18-24 HAWTHORNE STREET

APPLICATION FOR PERMIT

Memorandum from Department of Building Inspection, Portland, Maine

22 Hawthorne St. -- Alterations to dwelling for Pasquale Spisuoco by Breggy Construction Co. -- 11/9/55

22 Hanthome St

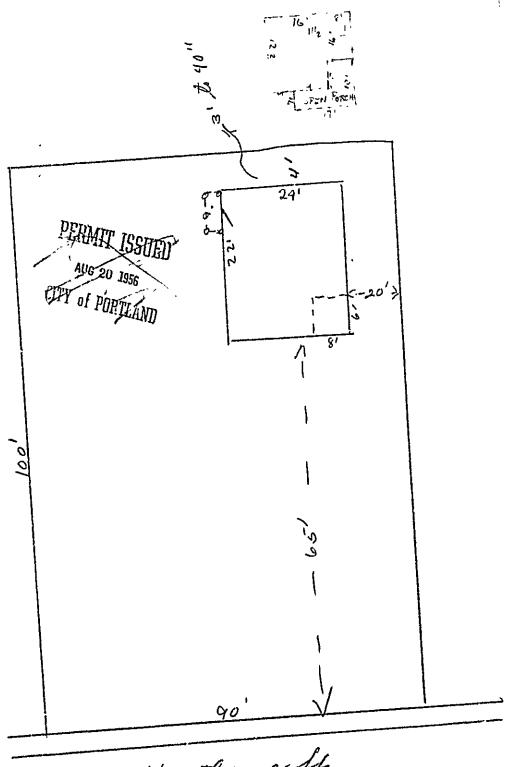
246 241001 8/21/6 8/21/56 Please see how this building is located tance to rear lot live and right band side wall of build is to lot line durding this property, which consists of his 45 foot wide (15. This is to ne relationship determ of proposed aide
